Office Action Summary	Application No. 10/002,811	Applicant(s) STRAND, AARON L.	
	Examiner Stephen Choi	Art Unit 3724

DETAILED ACTION

3. Claims 10-13, 17-19, 24-25, 28, and 30 are rejected under 35 U.S.C. 102(b) as being anticipated by Fitz, jr. (US 5,417,134).

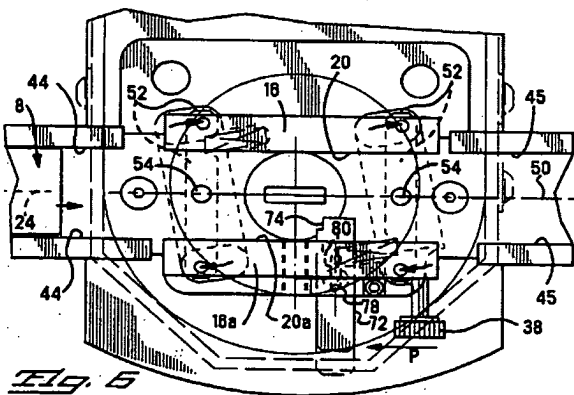
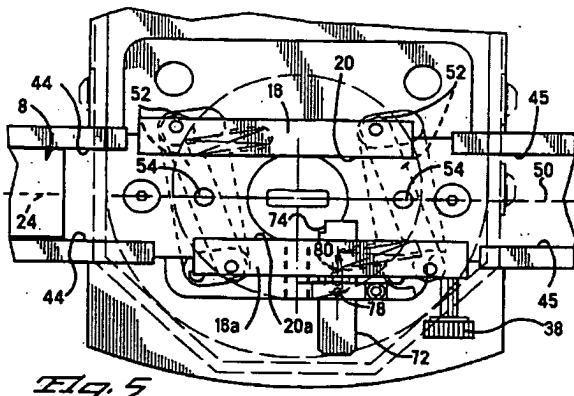
Fitz discloses all the recited elements of the invention including:

a) a housing (2) having a first slot, a second slot, and an open region (at 42);

b) a punch (3);

c) a guide slideable into the open region wherein the guide entering the open region in a plane that is generally parallel to the slot plane (see Figure below, the guide (16, 16a) is adapted to be slideably converge from the position shown on Figure 6 to the position shown on Figure 5 that is further into the open region). Regarding claims 13 and 30, the guide having a stepped edge (16, 16a, Figure 4). Regarding claims 17-19 and

As pointed out above, the guides of Fitz are adapted to be slideably converging from the position shown on Figure 6 to the position shown on Figure 5 that is further into the open region. The claim does not preclude the guides being always located in the opening. The claim merely requires "a guide slideable into said open region". The guides of Fitz are adapted to be slideable further into the open region.
